QUALITY ASSURANCE -- NON-CONFORMANCE REPORT

Report No: NCR-000652

Reference Description: Base Metal Repair without Engineer's Approval, East Tower, Lift 4, Skin E

Job Name: SAS Superstructure
Document No: 05.03.06-000611

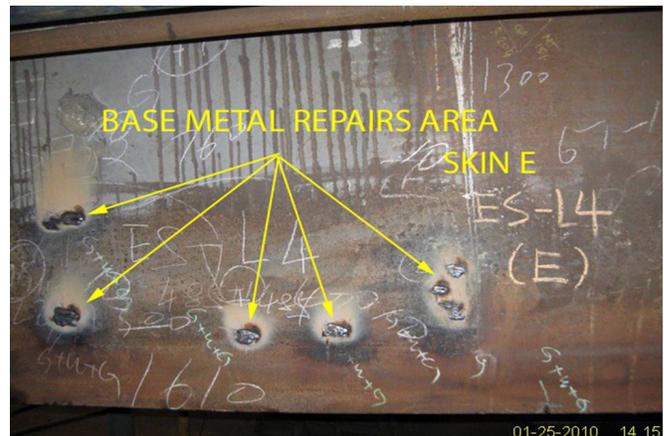
Caltrans Quality Assurance (QA) observed base metal repairs were performed without prior approval from the Engineer. These repairs were performed using the Shielded Metal Arc Welding (SMAW) process at East Tower, Lift 4, Skin E, on Seismic Performance Critical Member (SPCM) 485 grade material.

AWS D1.5-2002 Section 3.7.4; "Prior approval of the Engineer shall be obtained for repairs to base metal."

Propose a resolution for the identified non-conformance, documenting that the repaired base metal / welding repair is in compliance with the contract requirements. Documentation provided for the Engineer's review of the acceptability of the weld repair shall at a minimum include the procedure utilized/CWR and the NDT results.

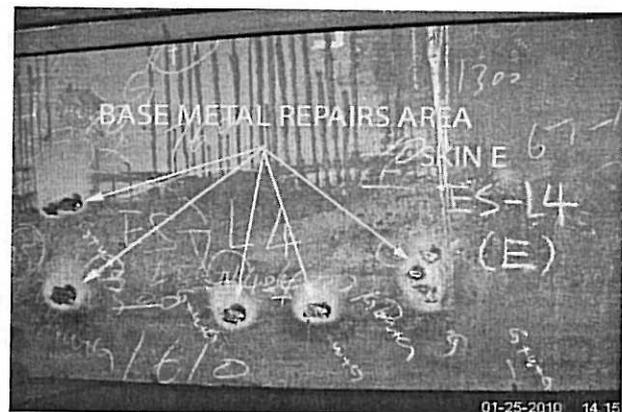
Caltrans Quality Assurance (QA) observed base metal repairs were performed without prior approval from the Engineer. These repairs were performed using the Shielded Metal Arc Welding (SMAW) process at East Tower, Lift 4, Skin E, on Seismic Performance Critical Member (SPCM) 485 grade material.

AWS D1.5-2002 Section 3.7.4; "Prior approval of the Engineer shall be obtained for repairs to base metal."

焊缝返修位置示意图:**Draft of welding discontinuity:**

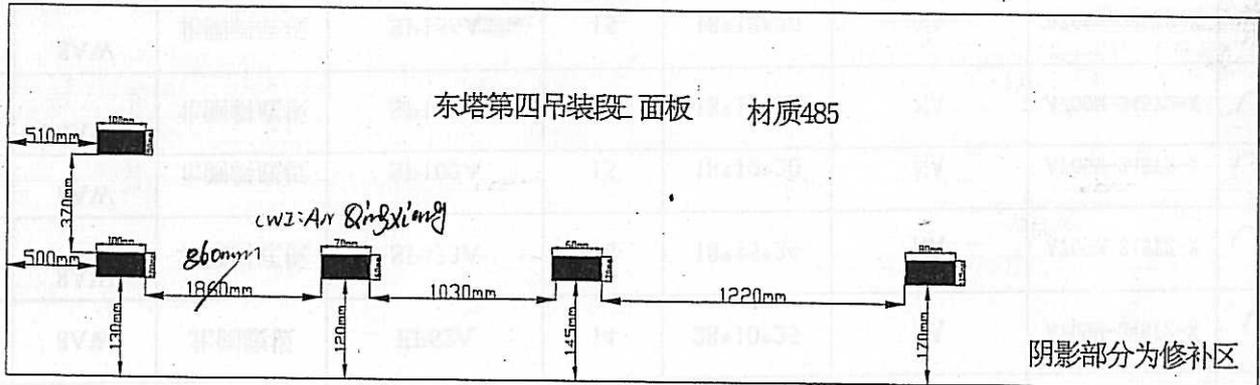
Fourth lifting east tower Skin E, the base metal was found damaged after grinding, 3-8mm in depth and needed to repair, the detail see the draft.

East tower fourth lifting Skin E metal degree 485

Repair area in shadow.

Train and educate operator to improve operation skill.
